ADDENDUM NO: 2

Project /Commodity: Callahan Hall Renovations

**NKU Callahan Hall Renovation
ADDENDUM # 2 - MEP**

NKU Callahan Hall Renovation
ADDENDUM # 2 - MEP **March 23, 2021**

E4.1

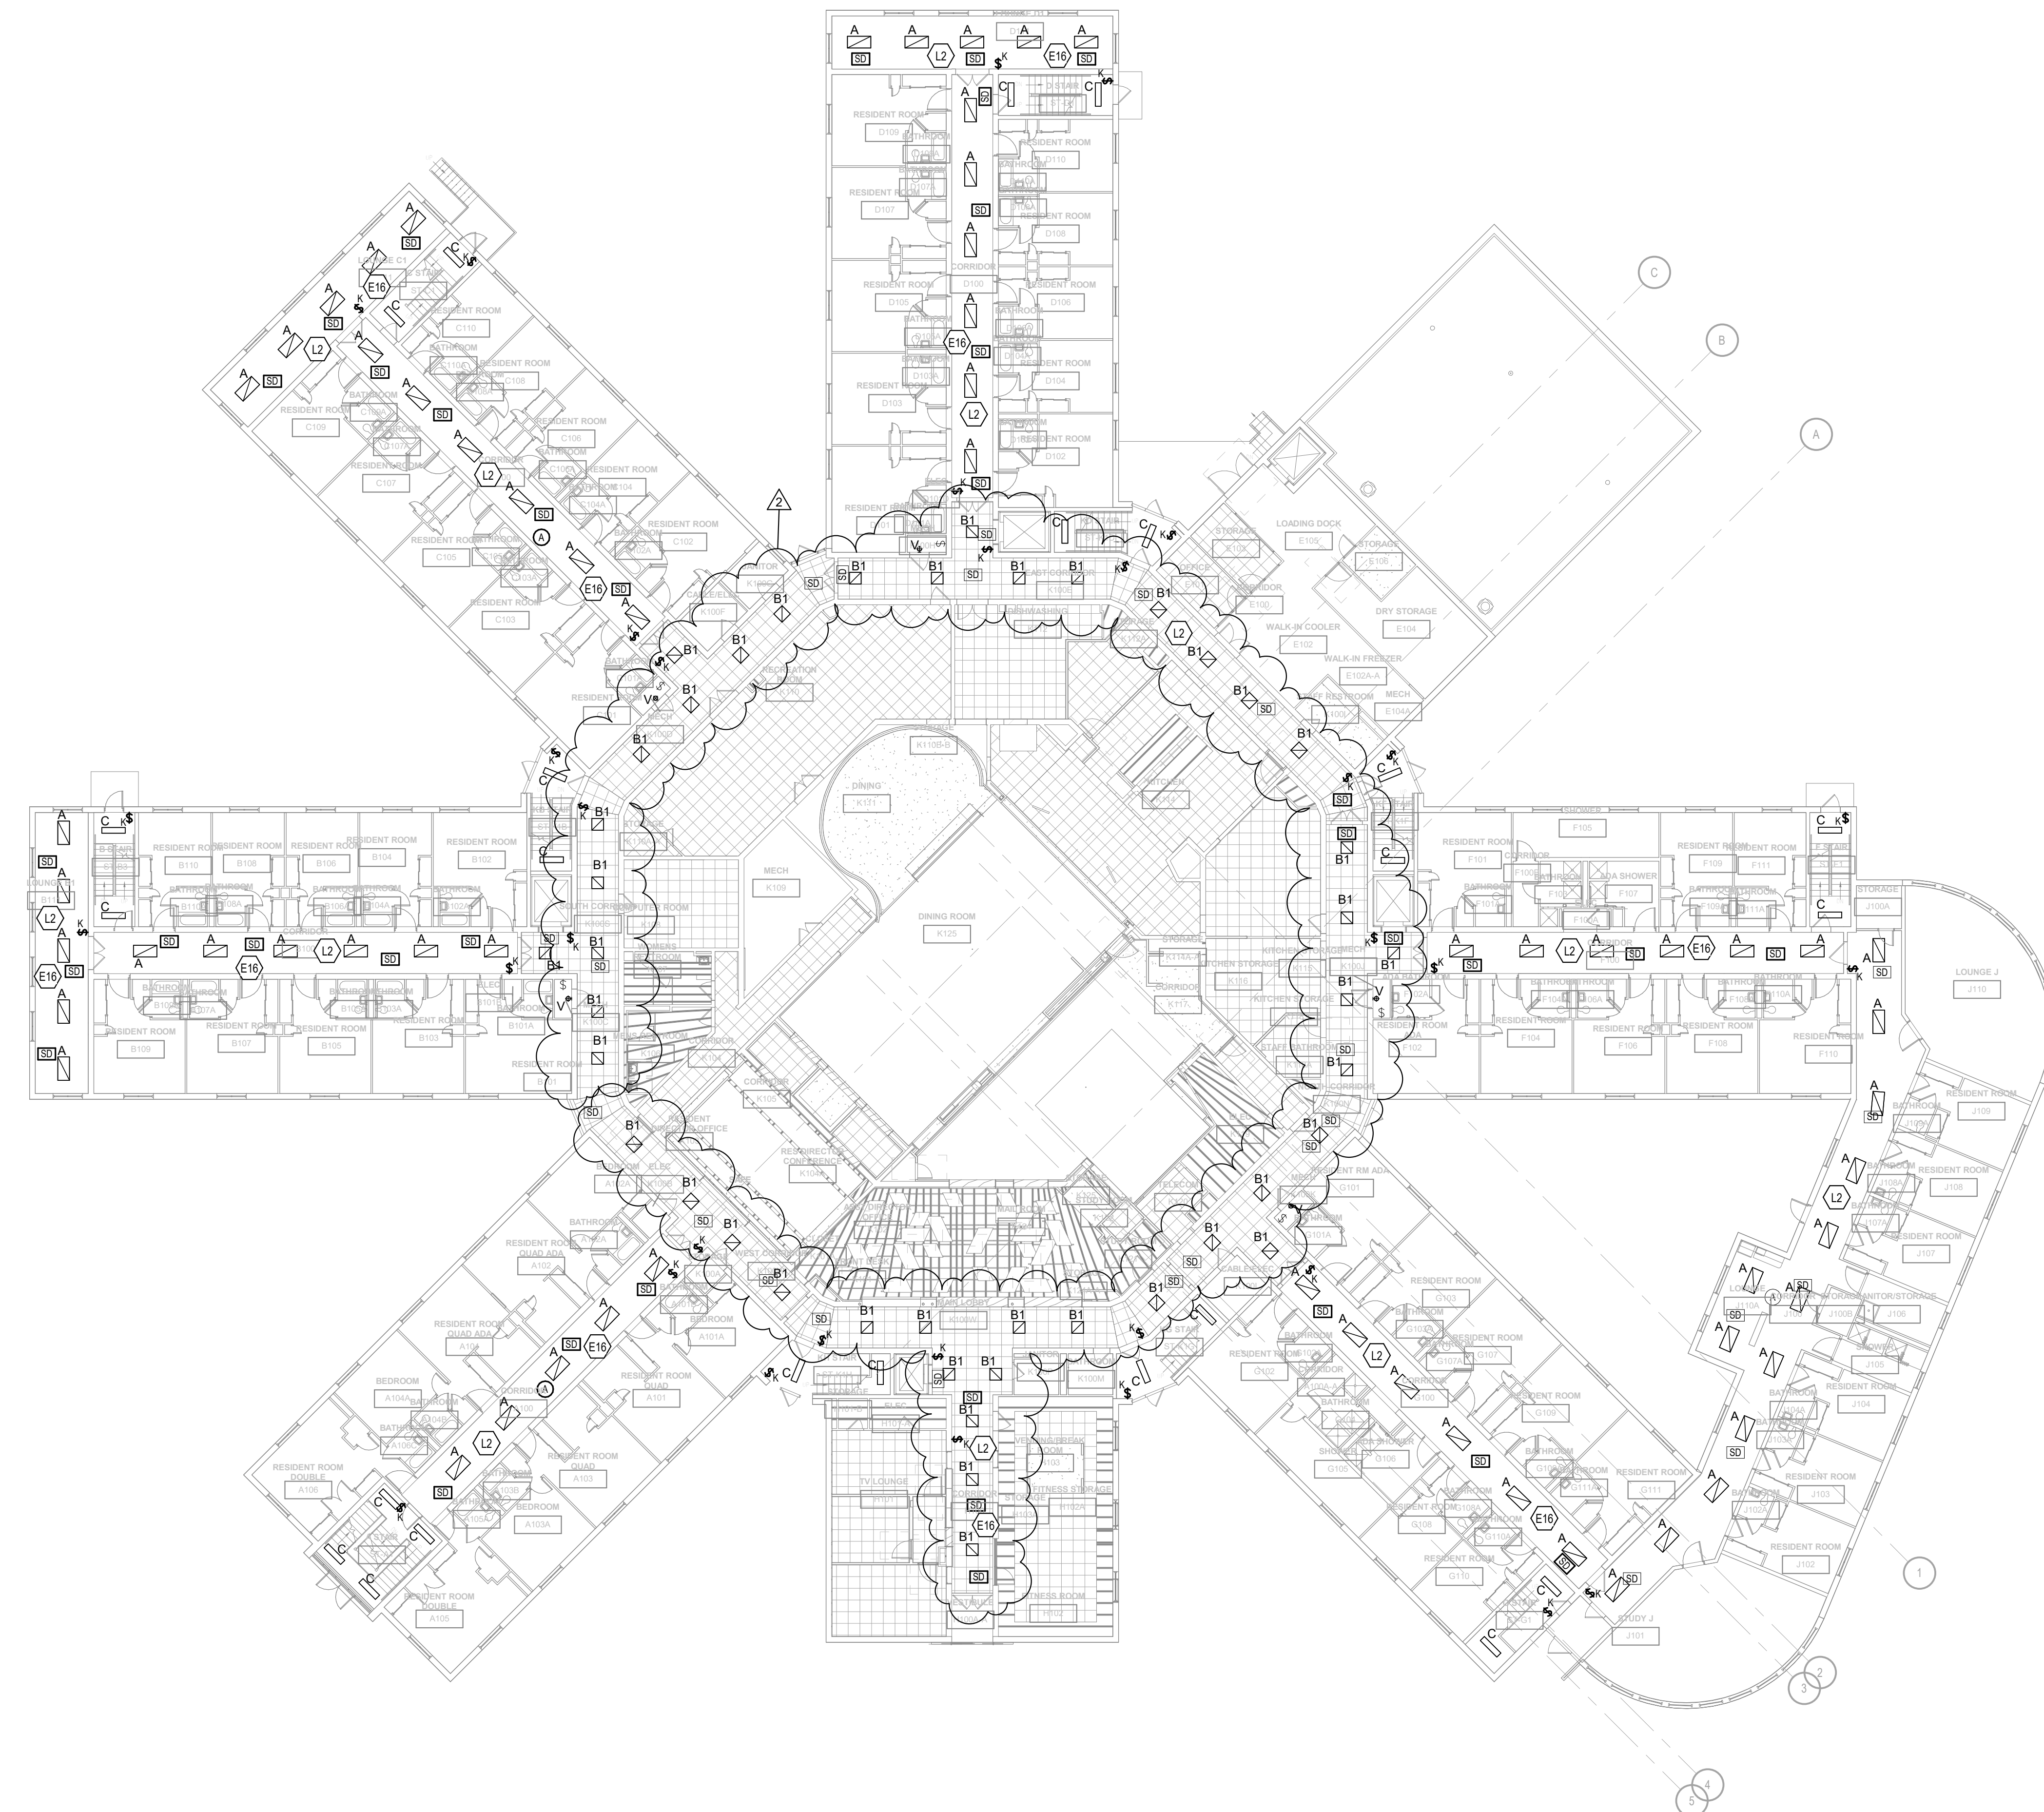
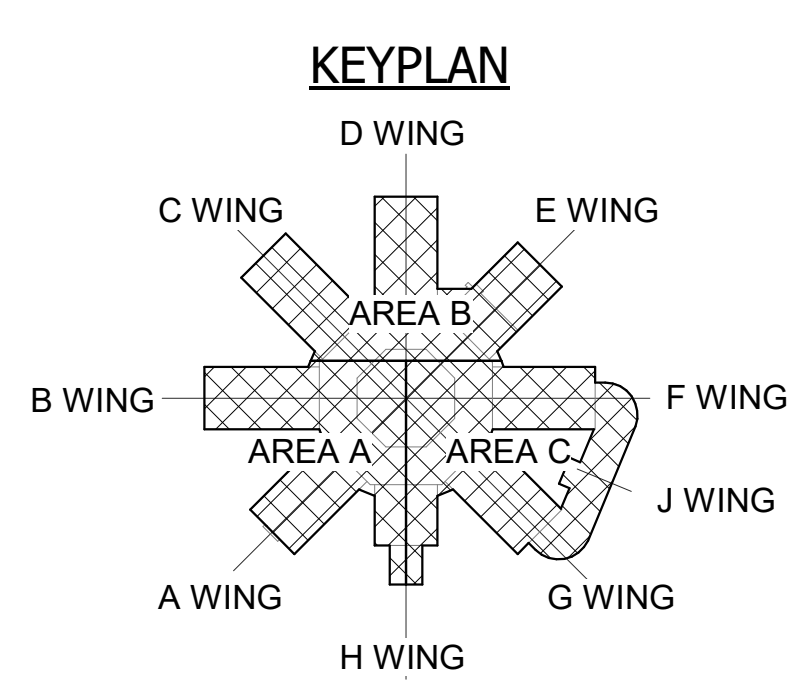
- Item #3 Refer to Electrical Drawing E4.1
- A. Refer to the revised E4.1 attached for a new fixture layout utilizing 2x2 fixtures that can work with the existing ceiling grid.
